Division of Air Pollution Control Response to Comments

Draft Regional Haze State Implementation Plan for the Second Implementation Period – Public Comment Period

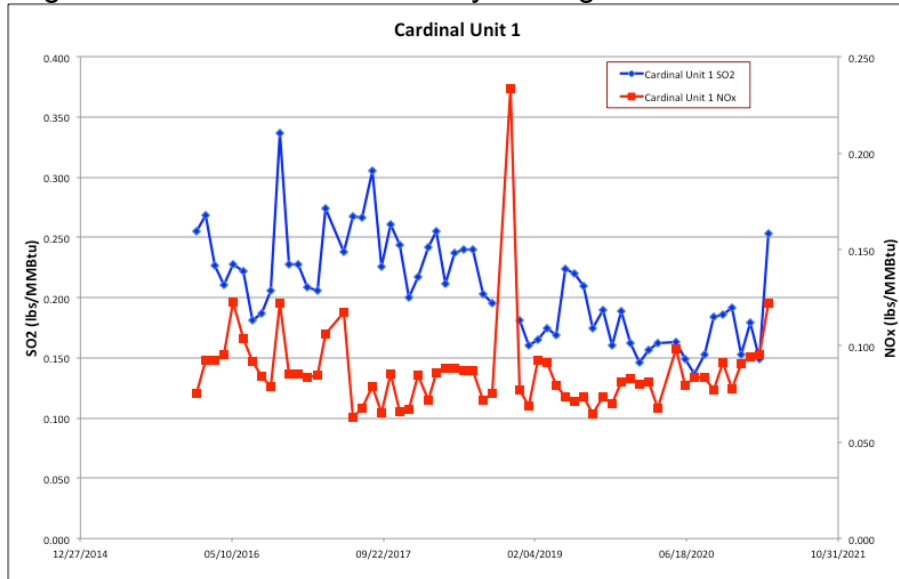
- Response 17:** These errors have been corrected.
- Comment 18:** “Ohio uses annual emission averages to illustrate its points. Instead, because emission limits are conditioned in the regional haze program on the basis of 30 day rolling averages, or better yet, 30 Boiler Operating Day (BOD) averages, Ohio should base its evaluations on that type of emission data. Below are 30 day monthly averages for the Cardinal Units:

Response 18: Neither the Regional Haze Rule nor Regional Haze Guidance specifies which averaging time is most appropriate for use in these analyses. Ohio believes use of an annual emissions average is acceptable for these purposes but has reviewed and considered the additional information provided by the commenter.

“Figure 5. Cardinal Unit 1 Historical 30 BOD NO_x Performance

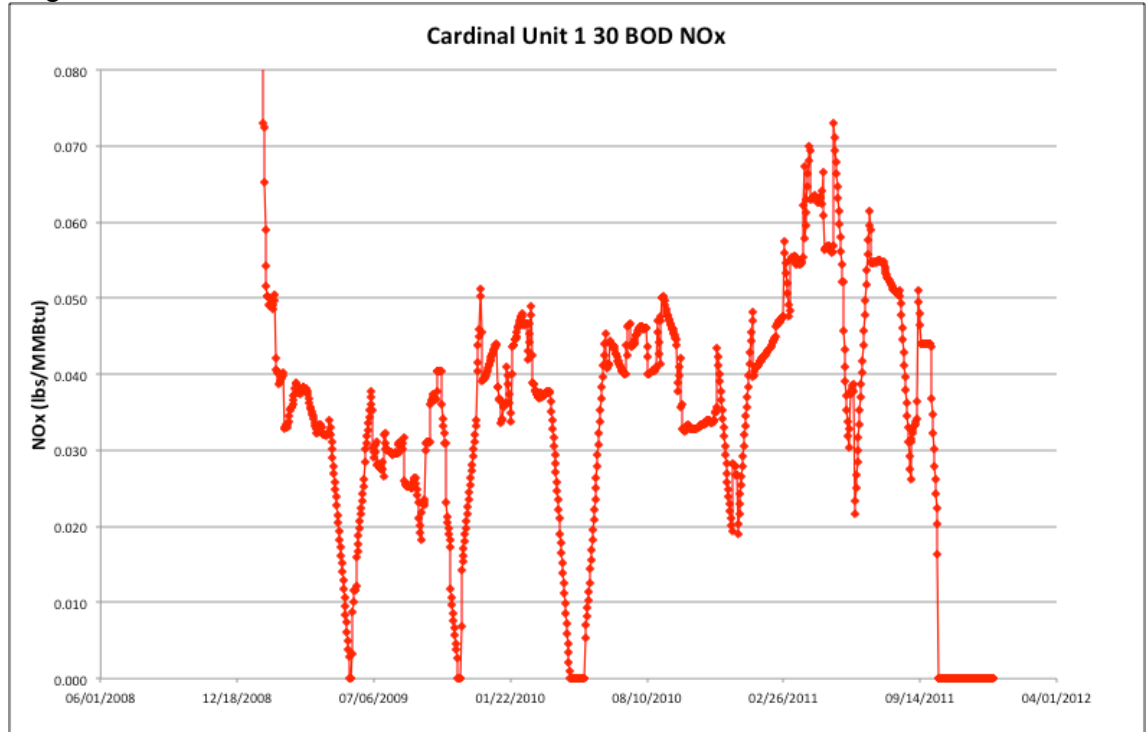
“It appears from the above graphs that the performance of Cardinal’s SCR systems is suboptimal, with recent monthly NO_x averages typically ranging from 0.06 – 0.12 lbs/MMBtu. As indicated above, the performance floor for coal-fired EGUs is at least 0.04 lbs/MMBtu, if not lower. In fact, Cardinal Unit 1 formerly had one of the best performing SCR units in the U.S., as the following graphs indicate:

“The above figures illustrate the Cardinal Unit 1 SCR system performance during two different time intervals. The NOx emissions are plotted based on a 30 BOD average. As can be seen from Figure 4, the Cardinal Unit 1’s SCR performance has gradually worsened over time. Figure 5 illustrates the SCR performance for the first two years after it was first installed. As can be seen, the SCR system is capable of sustained performance under 0.04 lbs/MMBtu. An examination of Cardinal Units 2 and 3 SCR systems reveals similar capabilities. In fact, the performance of the Cardinal Units’ SCR systems was formerly so good that EPA included it in its survey of the best coal-fired EGU SCR systems to support its New Mexico FIP, which concluded that SCR systems for the San Juan Generating Station were not only cost-effective, but should be required to meet a NOx rate of 0.50 on a 30 BOD average. It appears that the only thing preventing the Cardinal units from achieving this level of SCR performance again is the lack of an enforceable NOx limit requiring it. Consequently, Ohio should require that a four-factor NOx analysis be performed, as it appears likely that additional NOx reductions could be achieved very cost-effectively.

Response 19: Ohio EPA continues to conclude that these units are effectively controlled for SO₂ and NO_x. We consider the standard here to be *effectively* controlled, not *perfectly* controlled. Ohio recognizes there may be some variability in the emission rate over time. Even if there should be some small amount of additional emissions reductions that could be achieved with further optimization or control upgrades, we conclude that it is reasonable to assume for the purposes of efficiency and prioritization that a full four-factor analysis would result in the conclusion that no further controls are necessary.

“Figure 7. Bay Shore Unit 1 Monthly Average SO₂ and NO_x emissions

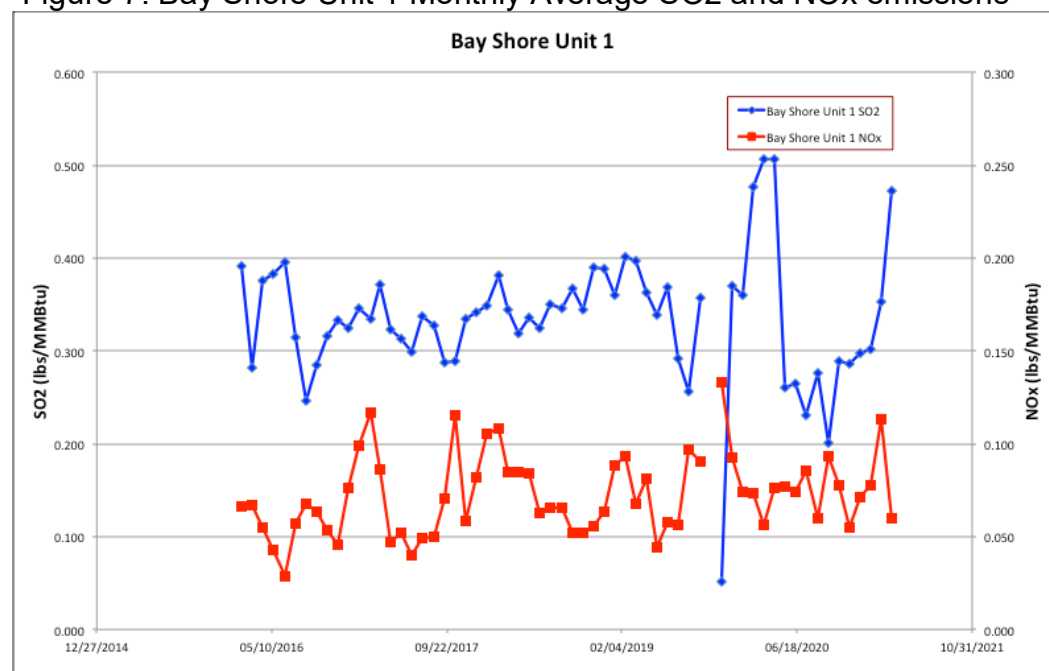
“On page 30, Ohio discusses the emissions of the Bay Shore Unit B006 (Unit 1). Similar to its discussion of the Cardinal units, Ohio states that it has a SO₂ limit of 0.73 lb/MMBtu on a 30-day rolling average basis and is required to meet 90% reduction of SO₂ (except that 70% reduction is allowable for all heat inputs less than 0.60 lb SO₂ /MMBtu). It also has a NO_x limit of 0.20 lb/MMBtu on a 30-day rolling average basis. Ohio points to annual SO₂ emissions of 0.32 – 0.34 lbs/MMBtu and annual NO_x emissions of 0.06 – 0.08 lbs/MMBtu. As with the Cardinal units, an examination of the monthly emissions provides more detail:

“As with the Cardinal units, Bay Shore has been operating considerably below its permitted 30-day SO₂ limit of 0.73 lbs/MMBtu. Also similar to the Cardinal units, Bay Shore cannot meet its MATS SO₂ limit (0.3 lbs/MMBtu when burning pet coke) and so presumably satisfies MATS by alternatively meeting an HCl limit. Therefore, the permit SO₂ limits for the Bay Shore Unit 1, do not guarantee future performance. In fact, as can be seen from the above graph, there are significant recent excursions from Bay Shore’s better historical SO₂ control. This indicates that Bay Shore’s permitted SO₂ rates should be tightened. In addition, there are instances in which the monthly SO₂ emission rate has averaged 0.25 lbs/MMBtu or less. Assuming a relatively stable coke sulfur content, this would indicate additional SO₂ control could be brought to bear. Lastly, there is no technical reason why post combustion controls such as DSI cannot be installed on a CFB boiler such as Bay Shore Unit 1. This would likely result in significant additional SO₂ reductions. For these reasons, Ohio should require that Bay Shore perform a four-factor analysis.

As discussed in more detail in Response 5 regarding enforceable limits, Ohio agrees that enforceable limits are required for those measures determined necessary for reasonable progress. In this case, Ohio is not relying on control measures at Bay Shore Plant for reasonable progress; therefore, enforceable limits are not required.

Figure 12. Kyger Creek Unit 1 Recent NO_x and SO₂ Monthly Emissions

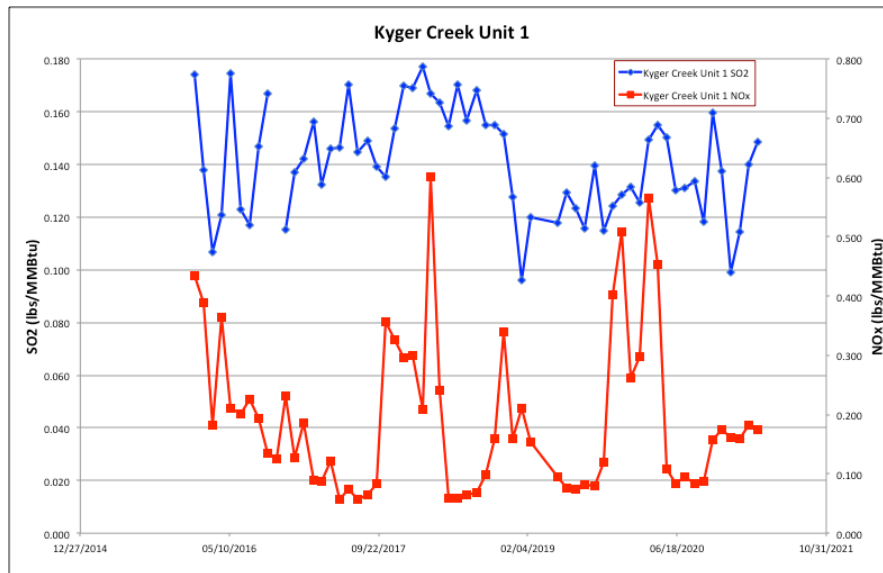
- Comment 23:** “This review included the material Ohio presents beginning on page 35 of its SIP and the additional material it cites to in Appendix L4, Attachment 1. Ohio declined to require a four-factor analysis for any of the five Kyger Creek units, concluding that the existing scrubbers and SCR systems were operating well enough that they could be considered “effectively controlled.” As Kyger Creek indicates on page 2 of Appendix L4, Attachment 1, Units 1 and 2 share a scrubber and CEMS and Units 3, 4, and 5 share a scrubber and CEMS. Thus, the monitoring data available from EPA’s AMPD website is apportioned and cannot be thought of as being particular to each unit. Analysis indicates that the NOx and SO2 data for Units 1 and 2 are very similar and that for Units 3, 4, and 5 are very similar. Therefore, only monitoring data for Units 1 and 3 are referenced below:

“As can be seen from the above graphs, the performance of the Kyger Creek SCR systems alternates between 3-4 month periods of good NO_x removal (approximately 0.06 – 0.08 lbs/MMBtu) with the rest of the time consisting of poor NO_x removal. On page 35 of its SIP, Ohio states that Kyger Creek operates its SCR systems year round. However, it seems evident the facility only utilizes its SCR systems at their full capabilities during ozone season. This indicates that the true current performance potential of the Kyger Creek SCR systems is likely at least 0.06 lbs/MMBtu. The pre-SCR NO_x level of Unit 1 is shown below:

Response 23: As discussed in Comment 21, Kyger Creek has provided additional information and clarification regarding their NOx emissions (please see Appendix P5). Ohio EPA continues to conclude based on a case-by-case evaluation of the control efficiency, emission rate, year-round control operation, and operational improvements and visibility impacts described further in the attachment that Kyger Creek is effectively controlled for NOx. We consider the standard here to be *effectively* controlled, not *perfectly*

Figure 14. Kyger Creek Unit 1 Historical NOx Monthly Emissions

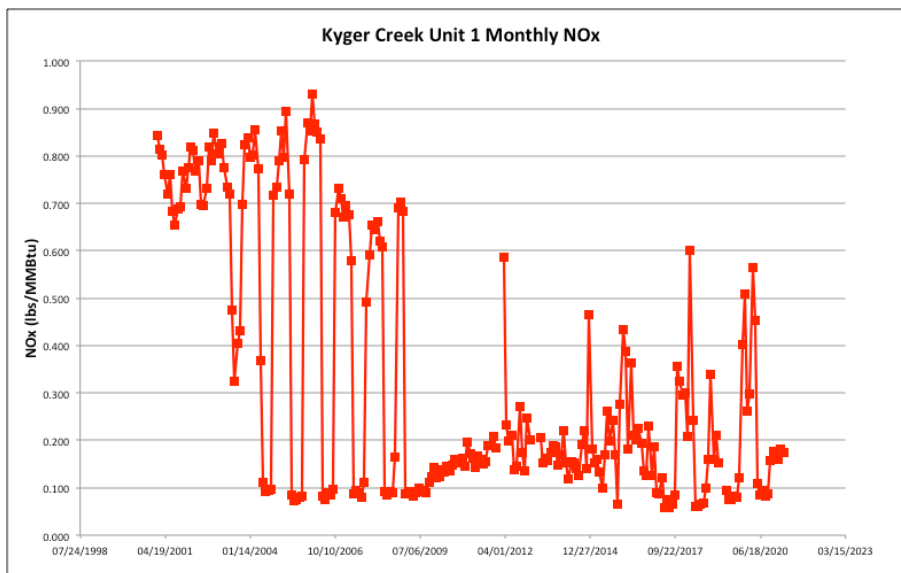
“Averaging the monthly NOx rates prior to the SCR installation in May, 2003 yields the following:

Figure 15. WH Sammis Unit 5 Recent NOx and SO₂ Monthly Emissions

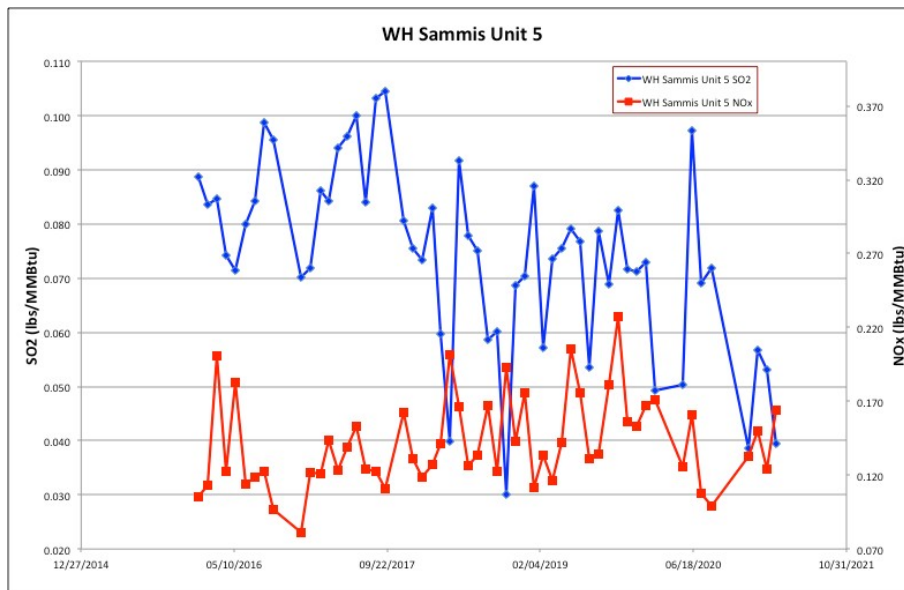
“According to information from Babcock and Wilcox Power, three absorbers were installed, which provided enough scrubbing capacity for all seven units. Sammis’ Title V permit indicates that all seven units were indeed scrubbed. Consequently, with four units now retired, it appears there is excess scrubbing capacity. However, it does not appear that the scrubber systems for Units 5-7 are being used to their full capacity, as the following graphs illustrate:

“Furthermore, as the above figures indicate, the scrubber performance of the three Sammis units is sporadic. Sammis’ CD and its Title V require that Units 5, 6, and 7 meet a rolling 30 day emission limit of 0.13 lbs/MMBtu. As can be seen from the above graphs, all three units operate considerably under that limit most of the time. In fact, it appears the performance floor for the scrubber systems is at least 0.060 lbs/MMBtu. Considering the capacity of the scrubber systems and its newness, this is not unexpected.

The SIP has been revised to include Unit 5 (B011). After analysis, Ohio concluded that this unit is also effectively controlled for SO₂ and NO_x. B011 has an FGD essentially getting the same level of control and subject

Figure 16. WH Sammis Unit 6 Recent NOx and SO₂ Monthly Emissions

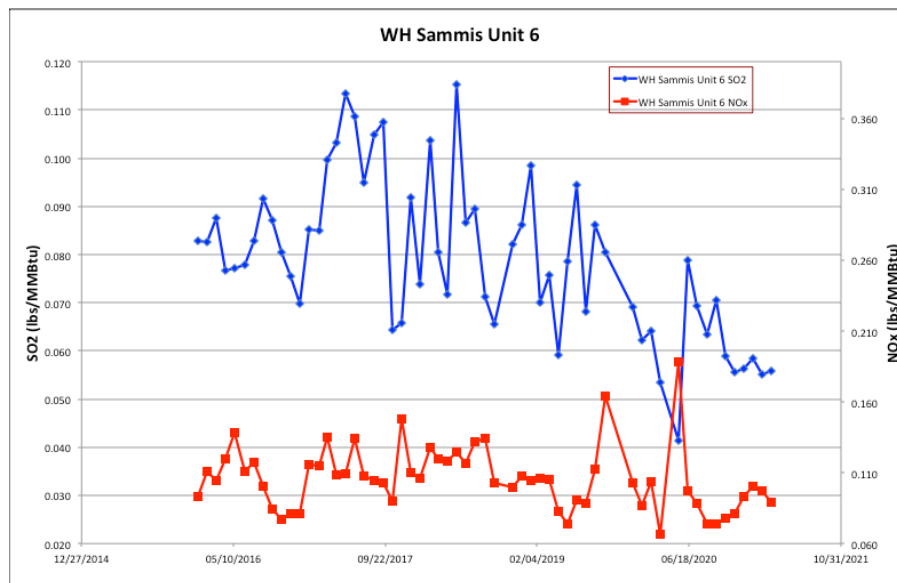
“Similarly, the SCR systems for Units 6 and 7 indicate that the performance floor is at least 0.07 lbs/MMBtu, as it appears the units regularly operate at those levels for 2-3 months at a time. Also, the SNCR system for Unit 5 appears capable of operating considerably below its CD and Title V rolling 30 day emission limit of 0.290 lbs/MMBtu. Therefore, Ohio should require a four-factor analysis for Units 5, 6, and 7 so that the performance of the scrubber, SCR, and SNCR systems can be optimized and their emission reductions secured. It is very likely that these improvements will prove to be very cost-effective.” **(Joe Kordzi Report attached to Conservation Organizations’ comments)**

Figure 20. Avon Lake Unit 9 (12) Selected 30 BOD NOx Emissions

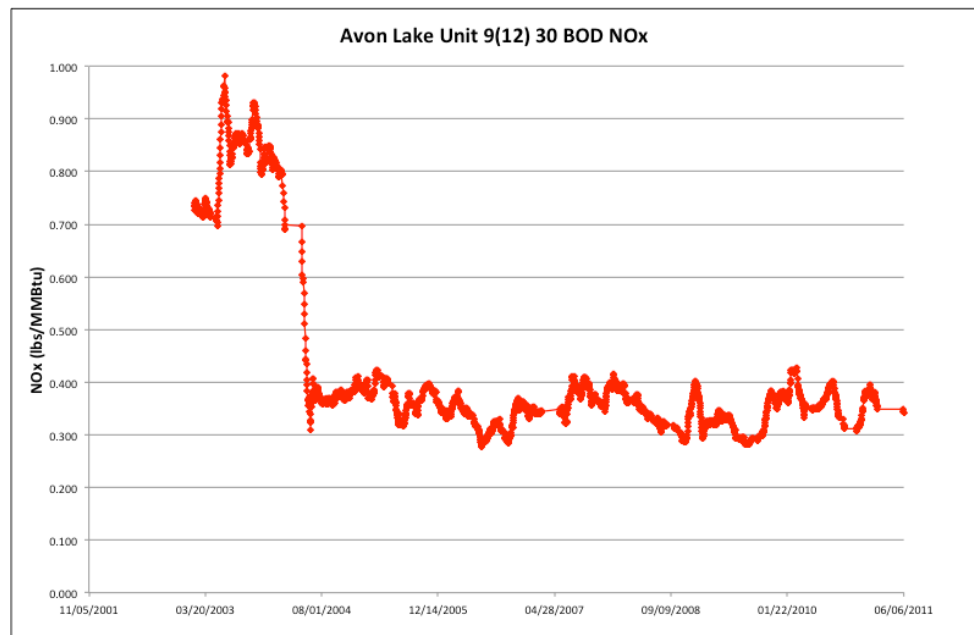
“The SNCR system that Avon Lake installed on Unit 9 (12) was functioning during the 2006-9 ozone seasons, as the following graph indicates:

“As can be seen from the above graph, it appears that use of the SNCR system during the ozone seasons of 2006-9 reduced the 30 BOD NO_x rate from approximately 0.4 to 0.3 lbs/MMBtu (or better). This represents a reduction of at least 25%. This level of control should be considered an average for urea-based coal-fired EGUs, with control level ranging up to 60% control, as the Control Cost Manual notes. In fact, considering all coal-fired boilers using both urea and ammonia reagents, a 25% level of control is at the low end of the range. Thus, Avon Lake’s assumption of 20% control appears to be unsupported. In its SNCR cost-effectiveness calculation, Avon Lake assumes a NO_x inlet of 0.327 lbs/MMBtu which it states is “based on actual operation in 2017 - 2019 at >300 MW.” That figure appears to be unsupported by the data contained in Avon Lake’s report. If the inlet is considered to be 0.4 lbs/MMBtu, which appears to be a reasonable figure based on the above graph, and Avon Lake’s own outlet of 0.262 lbs/MMBtu is used, then the control level becomes 35%.” (footnotes omitted) **(Joe Kordzi Report attached to Conservation Organizations’ comments)**

“Figure 8. Gavin Unit 1 30 BOD SO₂ and NO_x Average Emission Rates

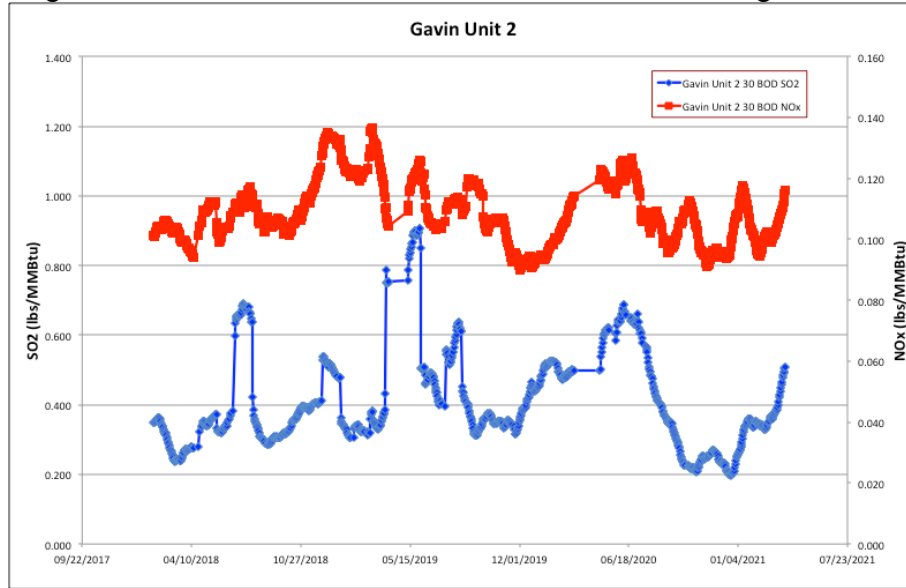
recycle pumps were installed, recycle pump motors were (as of the March 2021 date of the report) in the process of being upgraded, and an additive is used to add buffering to the recycle slurry. Gavin states these improvements increased the Liquid/Gas (L/G) ratio from 21-32 to 56. Once the recycle pumps are upgraded, it expects the recycle pump rate to further increase, resulting in an even higher L/G ratio.³² Gavin states that with these improvements, its wet scrubber systems have been operating at just above 95% control efficiency since the improvements were completed in mid-2020. Below is a graph of the Gavin Unit 1 and Unit 2 SO₂ and NO_x emissions before and after these improvements:

“As the above graphs illustrate, the Gavin SO₂ removal performance is fairly erratic, ranging from approximately 0.2 – 0.6 lbs/MMBtu for both units. There does not seem to be any indication of a clear performance improvement following the mid-2020 scrubber improvements that Gavin describes. This may in part be due to variability in the coal Gavin burns, which the EIA reports as “refined coal.” Below is the sulfur content of the coal Gavin reported to the Energy Information Agency (EIA) for 2020:³³

Figure 10. Gavin Unit 1 Historical Rolling 30 Day NO_x Performance

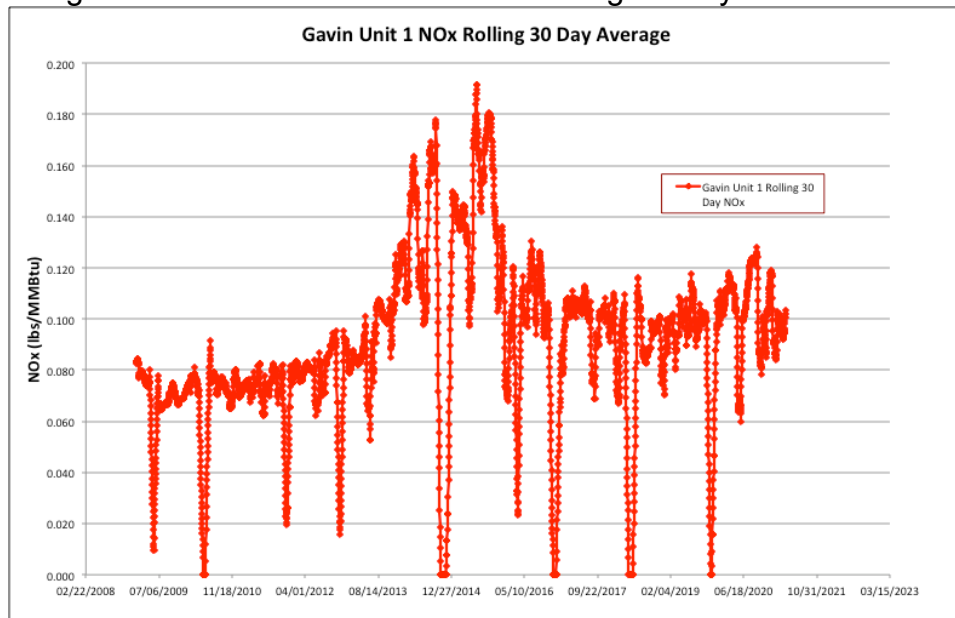
“Like the Cardinal Units, the Gavin SCR systems have historically performed better than they have done recently. Below are the historical rolling 30 Day NO_x graphs for Units 1 and 2³⁴:

“As can be seen from the above graphs, the SCR systems for both the Gavin units performed significantly better during the time period from at least January 1, 2009 to July, 2012 – a period of at least 3-1/2 years. Regarding this, Gavin states on page 4 of Attachment 2 to Appendix L:
